**COUNTY OF WESTCHESTER
NEW YORK**

ADDENDUM NO. 2

CONTRACT NO. 23-528

**NEW SNOW EQUIPMENT STORAGE BUILDING
WESTCHESTER COUNTY AIRPORT
TOWNS OF HARRISON AND NORTH CASTLE AND
VILLAGE OF RYE BROOK, NEW YORK**

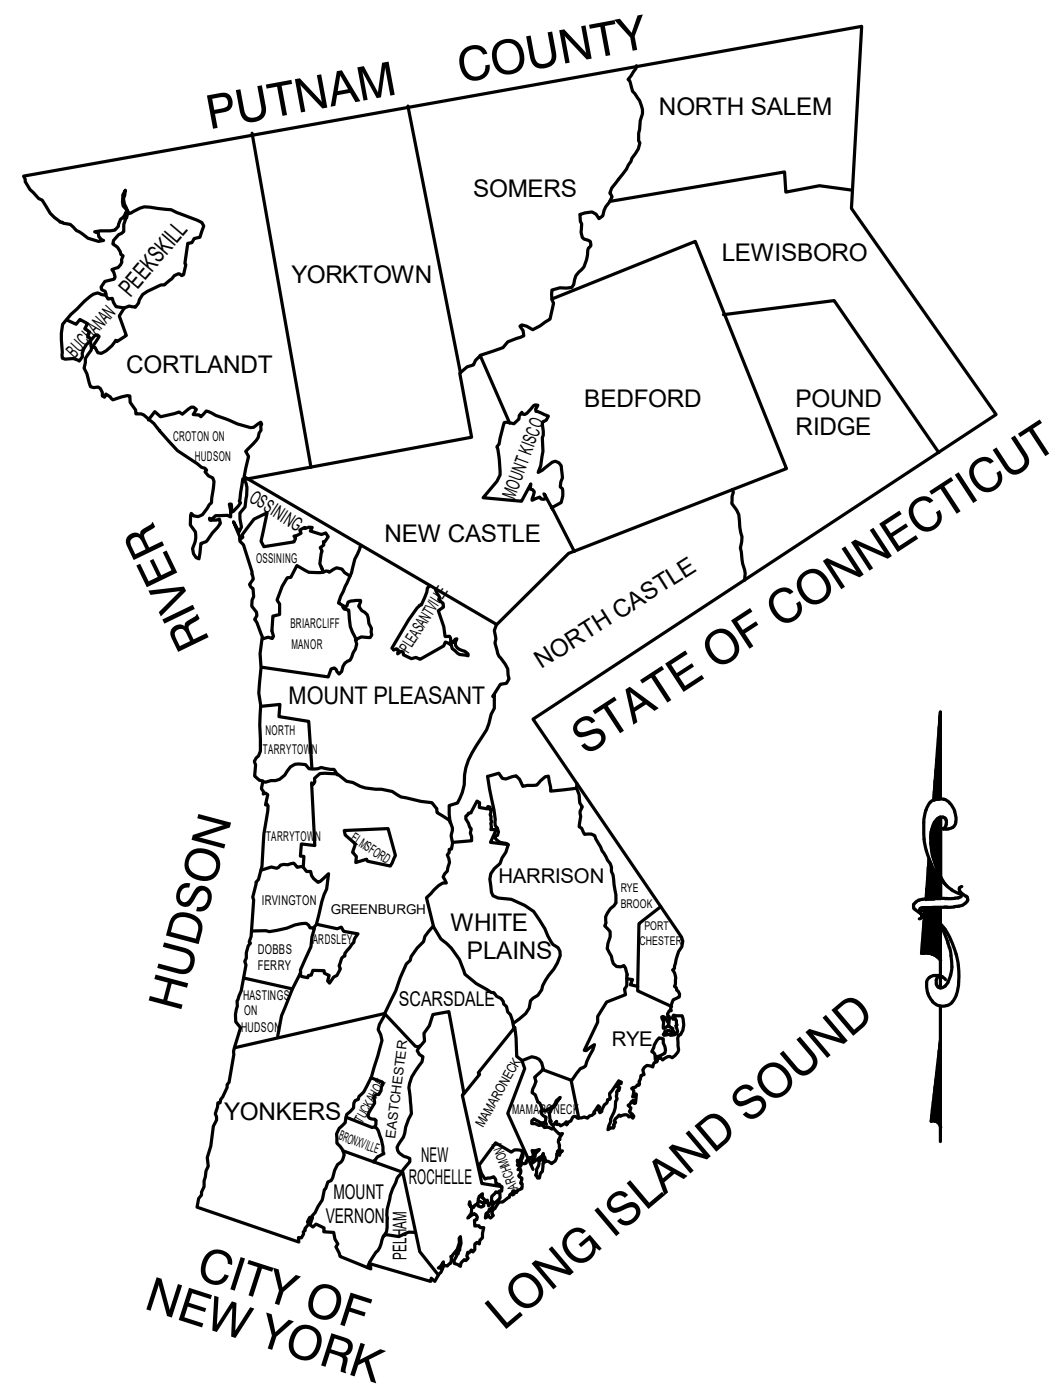
Q3: Where exactly is the ACCU located. The equipment schedule calls for a CMU wall bracket. The drawings note “on deck above”. Is that the roof deck? Or, the deck directly above the room. Or, on the wall using the spec’d wall bracket?

R3: ACCU-1 is located on deck directly above the room. No need for wall bracket for unit mounting.
